ALERT SERVICE BULLETIN

412-12-149
24 January 2012

MODEL AFFECTED: 412/412EP

SUBJECT: SIMPLE PENDULUM ABSORBER BRACKETS 412-010-264-101 / -105, INSPECTION AND REWORK OF

Figure 1. SPA bracket

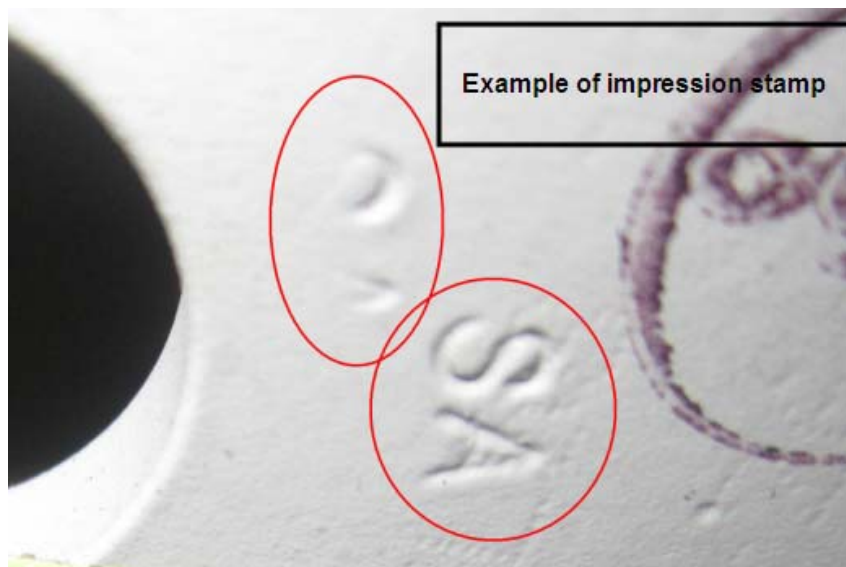
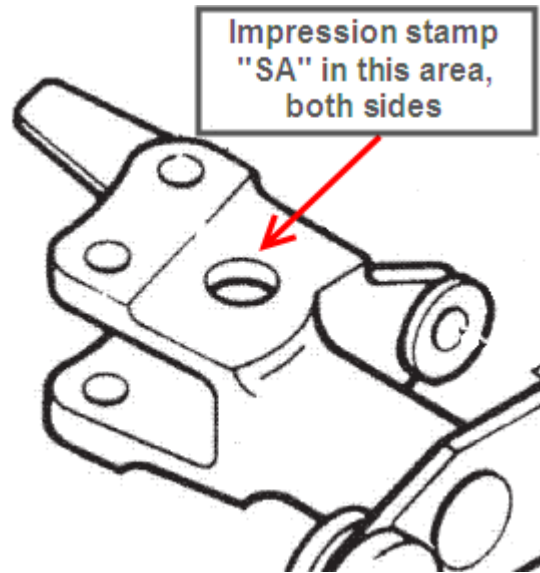
Some Simple Pendulum Absorber (SPA) brackets 412-010-264-101 (trailing edge) and -105 (leading edge) may have been manufactured with an impression stamp marking that does not conform to the design requirements. PART I of this bulletin mandates a one-time inspection of SPA brackets and PART II provides rework instructions if required. Applicability of this bulletin to any spare part shall be determined prior to its installation on an affected aircraft.

1. Prepare helicopter for maintenance.
2. Gain access to SPA bracket.
3. Inspect both sides of SPA bracket for presence of impression stamp "SA" or "A" in the area of the lightning hole. Refer to Figure 1.
4. If no impression stamp is found, the part is serviceable. Make an entry in the helicopter records to indicate findings and compliance with this Alert Service Bulletin.
5. If impression stamp is found, accomplish PART II.

Note: Impression stamp may be partial. The "S" or the "A" may have been removed when the lightning hole was made.

1. Prepare helicopter for maintenance.
2. Gain access to SPA bracket.
3. Strip the paint and primer in the area shown on Figure 1. Refer to the BHT-ALL-SPM.
4. Using Pin Mic gauge (or equivalent measuring device), measure the depth of the stamping.
 - a. If depth is at or less than 0.035 inch, the part can be reworked. Document the depth of the stamping and proceed with step 5.
 - b. If the depth exceeds 0.035 inch, replace the SPA bracket with a serviceable part. Make an entry in the helicopter records to indicate findings and compliance with this Alert Service Bulletin.

5. Using a coarse grit aluminum oxide grinding stone or equivalent, hand remove all evidence of marking as shown on Figure 1. Maintain a minimum blend radius of 1 inch. If rework extends into lightening hole, blend edges with adjacent surfaces to maintain equal or larger edge radii.

6. Using abrasive cloth (C-423) of appropriate grit, polish the reworked area to obtain a surface finish of 63 RMS.
7. After the proper finish has been obtained, perform a Dye Penetrant inspection (per product manufacturer's instructions) of the reworked area and look for any presence of a crack.

- a. If a crack is found, replace the SPA bracket with a serviceable part. Make an entry in the helicopter records to indicate findings and compliance with this bulletin.

- b. If no crack is found, prime and paint the reworked area. Make an entry in the helicopter records to indicate findings and compliance with this bulletin.
